Date: November 9, 2015
To: Portland Design Commission
From: Hillary Adam, Development Review
503-823-3581
Re: 15-229299 DA – SW 3rd & Taylor
Design Advice Request Summary Memo November 19, 2015

Attached is a drawing set for the Design Advice Request of two new buildings comprising 7/8 of the block, to include one hotel with a 4-story podium and 20-story point tower and a ½-block 10-story office building. The adjacent Auditorium Building is a historic landmark, separately owned, and is not included within this proposal. The existing Lotus Cardroom & Café and the Ancient Order of United Workers building, both of which were listed on the City's Historic Resources Inventory until November 5, 2015, are proposed to be demolished. Proposed exterior materials for the new buildings are as-yet unidentified. An Adjustment is expected to be requested to reduce the total number of required loading spaces on the entire block from four Standard A spaces to one Standard A space; no loading is proposed on the site of the office building.

Previous Design

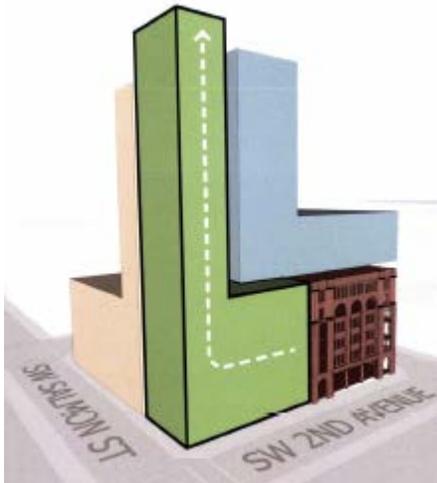
- **AOUW Building.** When this proposal was first discussed with City staff, the applicant proposed demolition of the Lotus Cardroom and Café and retention of the AOUW Building. The new office building was proposed to rise from the northwest corner of the block and extend over the AOUW Building. While staff was initially resistant to this idea, it became apparent that such a proposal could serve to rehabilitate the structure and could potentially, with some additional changes, result in a bold and dynamic architectural intervention as yet unseen in Portland. Unfortunately, the latest drawings show that the AOUW Building is now proposed to be demolished. Staff appreciates the Commission's comments regarding the currently proposed design versus the previously proposed design.

Previous Design

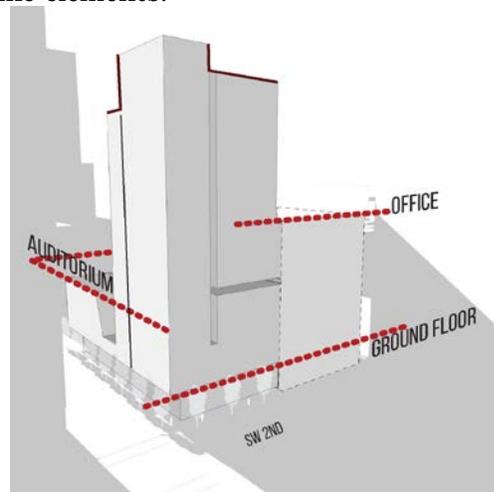
- **Hotel Building.** Staff notes that some aspects of the hotel building design appear to be remnants from the previous design, and no longer make sense with regard to the cohesiveness of the design; this is particularly true on the east façade. Staff notes that the design may be stronger if the darker portion of the east façade was more integrated with the design or if the datums aligned as in the previous version; currently, the changes in the façade articulation seem relatively arbitrary. It is also unclear what the proposed materials are for this building or the quality of the ground level treatment, including the canopy-like elements.
